ITEM IV-B: DESIGN REVIEW PERMIT FOR RESIDENTIAL SUBDIVISION – 10091 CROCKER RANCH RD – NRSP CROCKER RANCH NORTH PHASES 3A & 3B – FILE #2008PL-039 (DRP-0000255)

REQUEST

Figure 4: Front Yard Setback Variation/Plotting Exhibit

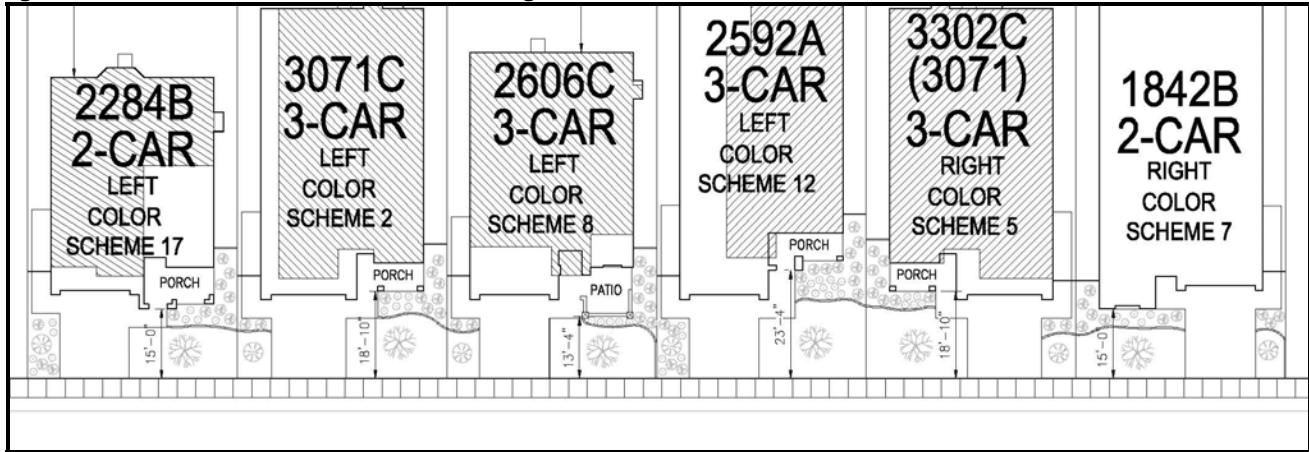
Although JMC would eliminate the front yard stagger, the plan layouts are such that there will be the appearance of a front yard stagger. As shown in the following Figure 4, Plan 3 has a 15 foot front yard setback to the porch, whereas Plan 1 has a front yard setback of 18'-10" to the front porch, and Plan 2 has front patio space with a 13'- 4" front yard setback.

Staff feels that the variation in plans and the layout of each plan will create sufficient setback variation, which meets, or exceeds, the intent of the of the front yard stagger. No modifications to proposed design standard are recommended.
